Re: Wilshire Grand Redevelopment Project – CPC-2009-3416-DA-TDR-CUB-CU-
CUW-ZV-SN-ZAD-SPR-GB; ENV-2009-1577-EIR-GB

Responses to the 1000 Wilshire letter dated February 21, 2011 and the Brookfield letter dated February 22, 2011

**Re: Wilshire Grand Redevelopment EIR –
Response to PBS&J Letter Dated February 17, 2011**

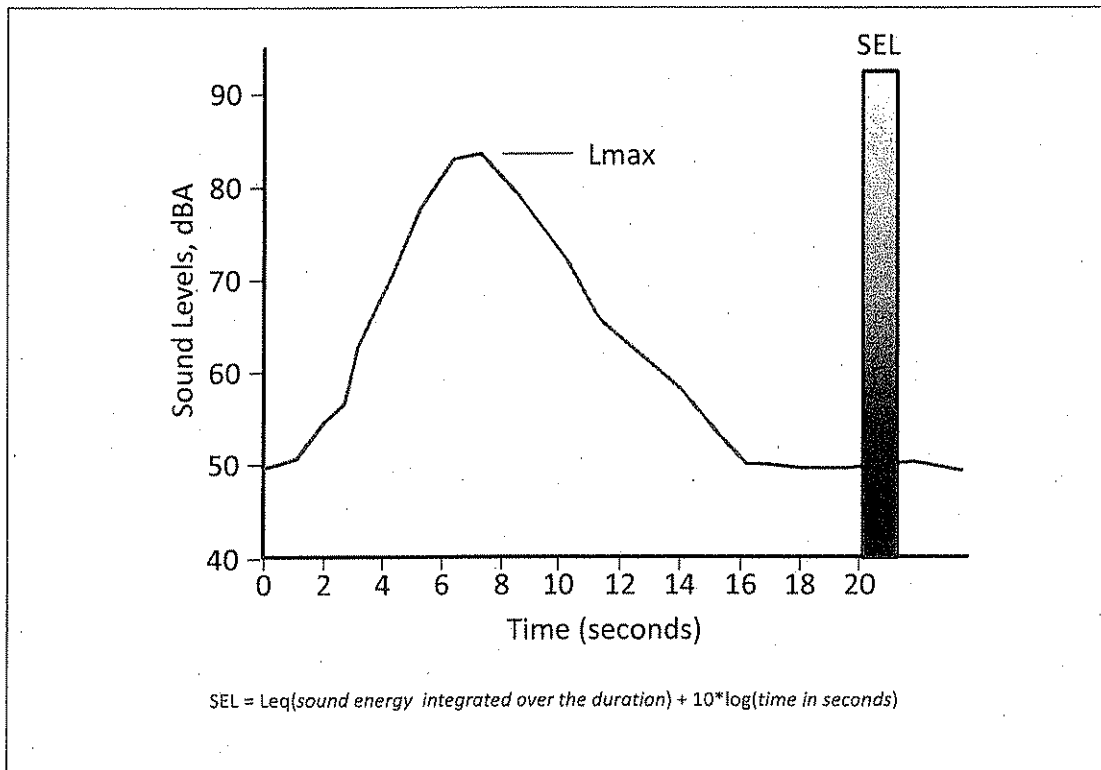
2. Page 1, second paragraph – *PBS&J states that single-event noise level (SEL) is the maximum noise level at a given resulting from a single event.*

The SEL noise metric is a calculated noise level that is normalized to a 1 second time interval. It is not the actual maximum sound level (L_{max}) that a person would hear. The figure below provides the relation of the between an SEL and the L_{max} noise descriptors. The curvy line represents a typical sound level from a single event (which lasts approximately 14 seconds). The maximum noise level that a person would hear is the peak, which occurred at approximately 7 second mark. The SEL is the calculated noise levels, which consists of the sound energy over the entire duration (approximately 14 second, in this figure) condensed into one second duration. The SEL noise level is widely utilized to evaluate sleep interference (for residential uses); where as speech interference (for office or school uses) is analyzed using L_{max} .¹
